**GILMAN SPRINGS IMPROVEMENTS PROJECT**

#### MODIFICATIONS / CLARIFICATIONS TO SPECIAL PROVISIONS:

**MODIFICATIONS / CLARIFICATIONS TO THE PLANS**

**Item 15: Plan sheet revisions.** The following Plan sheets are revised or added by Attachment "B" and made a part hereof

**MODIFIED ENERGY DISSIPATOR - IMPACT BASIN WITH VERTICAL BAFFLE WALL**  
**WIDTH = 12'-0"**  
**REVISED DRAINAGE DETAIL No. 2**  
 NTS

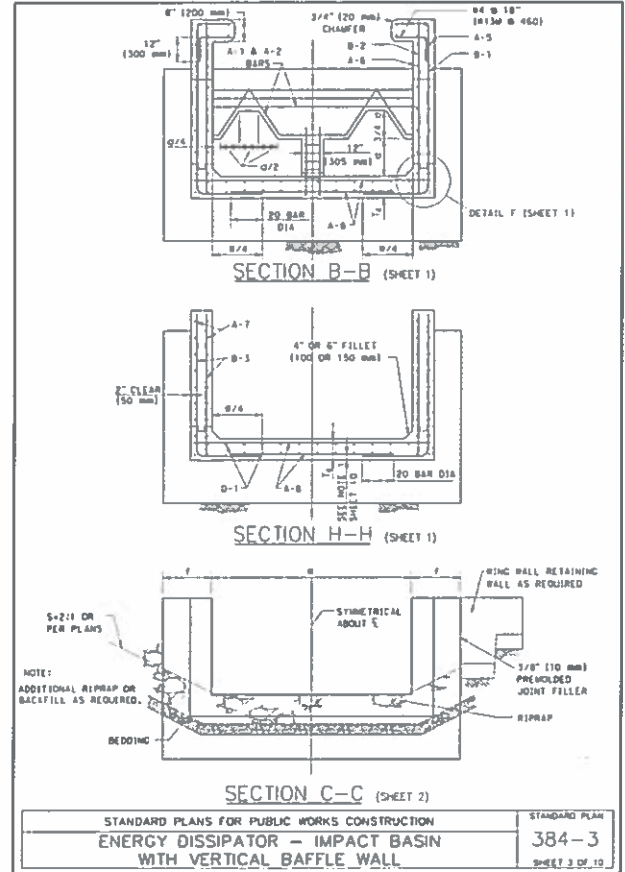
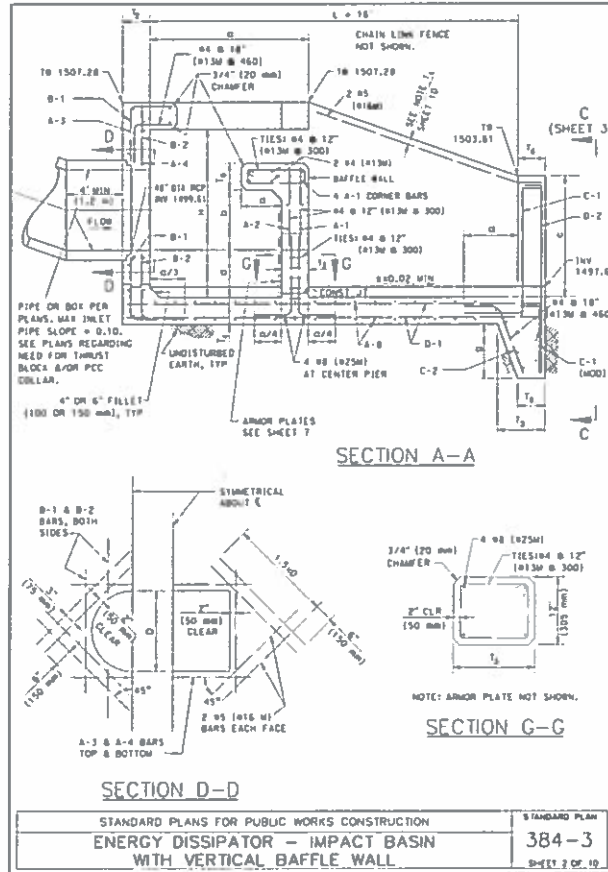
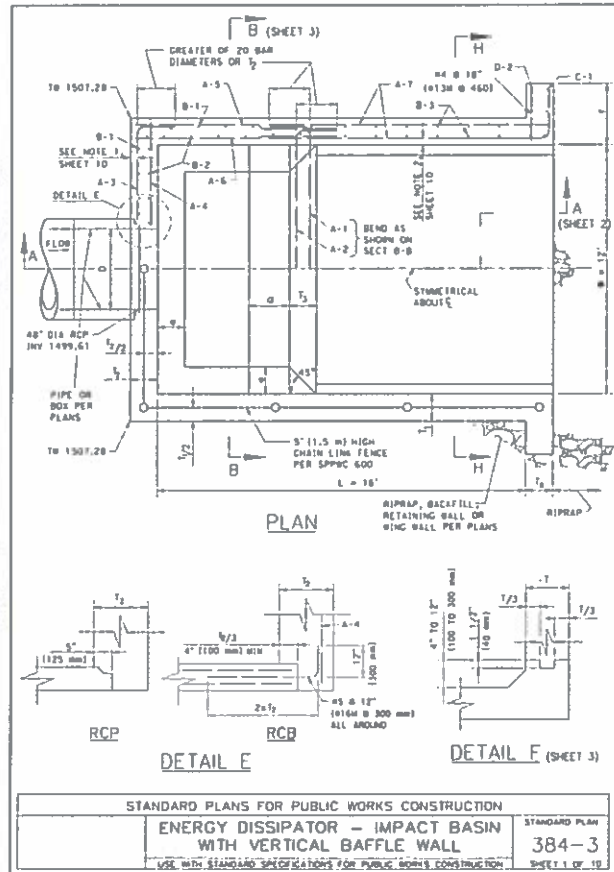
- **Energy Dissipator – Impact Basin with Vertical Baffle Wall per Standard Specifications for Public Works Construction (Greenbook) Standard Plan No. 384-3 (Modified)**

- 19 REMOVE EXIST CULVERT AND CONSTRUCT 48" RCP (D-LOAD 2000)
- 20 CONSTRUCT HEADBALL PER 2010 CALTRANS STD PLAN DRG
- 21 CONSTRUCT MODIFIED ENERGY DISSIPATOR PER SPP0C 384-3, SEE SHT C-1A

- NOTES:
1. DETAILS MODIFIED PER STD PLANS FOR PUBLIC WORKS CONSTRUCTION (SPPWC) NO. 384-3
  2. SEE SPPWC STD PLAN 384-3 FOR REMAINING SHEETS 4 THROUGH 10
  3. USE WIDTH = 12'-0"

DESIGNED BY	PAYEMENT DELINEATION & SIGN PLAN	SHEET No.
	APPROVED BY  DATE 7/6/18	GILMAN SPRINGS RD PAVEMENT REHABILITATION NO SCALE	PD-1 SHEET 8 of 13

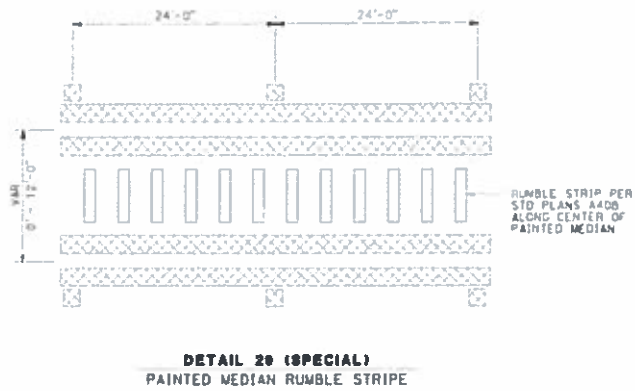
The limits of the fog seal application shall be the same as the striping limits as shown on Sheet PD-1 of the plans (sheet 7 of 8) except for the surface of the bridge.

1. CAL-TRACK STRIPING PRIOR TO INSTALLATION, AS DIRECTED BY THE RESIDENT ENGINEER
2. GRIND ALL THERMOPLASTIC STRIPING AND LEGENDS, AS DIRECTED BY THE RESIDENT ENGINEER
3. REMOVE EXISTING STRIPING DETAILS 27B, 3B AND 8" THERMOPLASTIC STRIPE, AS DIRECTED BY THE RESIDENT ENGINEER.
